Access Compliance Report

Public Rights-of-Way

Intersection ID: N/A	Main Street: ALLEGIANCE DR	Cross Street: LADY LIBERTY LN	Location: SW
ADA ID: 2AAFE2B3886B	Ramp Type: Perp	Initial Pass/Fail: Fail	Overall Compliance: No
			Severity Score: 33.75

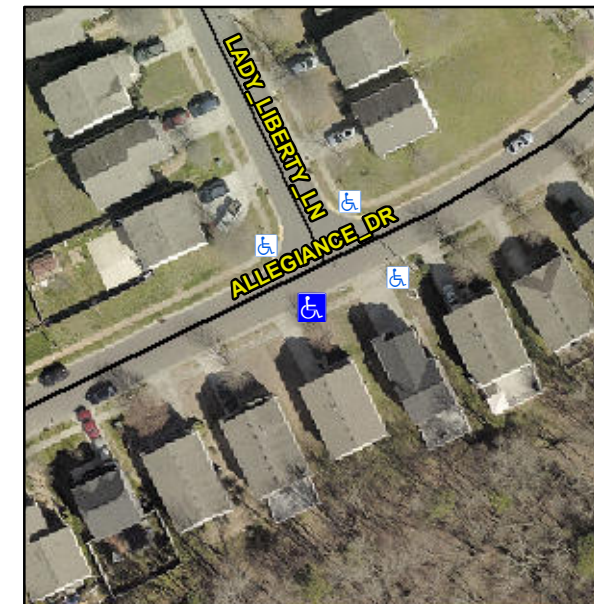
R304.5.1, R304.2.2, R304.5.3

Compliance	Description	Data	Compliance	Description	Data
N/A	Ramp Length (in)	48.0	No	Ramp Slope (%)	8.8
No	Ramp Width (in)	47.0	No	Ramp XSlope (%)	6.1
N/A	Flare Type LT	N/A	N/A	Flare Type RT	N/A
N/A	Flare Slope LT (%)	N/A	N/A	Flare Slope RT (%)	N/A
N/A	Flare Traversable LT?	No	N/A	Flare Traversable RT?	No
N/A	Landing Length (in)	N/A	N/A	DWS Provided?	N/A
N/A	Landing Width (in)	N/A	N/A	DWS Contrast?	N/A
N/A	Landing Slope (%)	N/A	N/A	DWS Length (in)	N/A
N/A	Landing X Slope (%)	N/A	N/A	DWS Full Width?	N/A
N/A	Landing Curb? (Y/N)	N/A	N/A	DWS Offset (in)	N/A
N/A	Shared Landing?	N/A			
N/A	Gutter Ponding?	N/A	N/A	Gutter Slope (%)	N/A
N/A	Gutter Lip Ht (in)	N/A	N/A	Gutter X Slope (%)	N/A
N/A	Painted X Walk1?	No	N/A	Painted X Walk2?	N/A
	X Walk 1 Direction	To N		X Walk 2 Direction	N/A
N/A	X Walk 1 Width (in)	N/A	N/A	X Walk 2 Width (in)	N/A
	X Walk 1 Slope (%)	0.2		X Walk 2 Slope (%)	N/A
	X Walk 1 X Slope (%)	1.5		X Walk 2 X Slope (%)	N/A

Remove & Replace Entire Ramp.
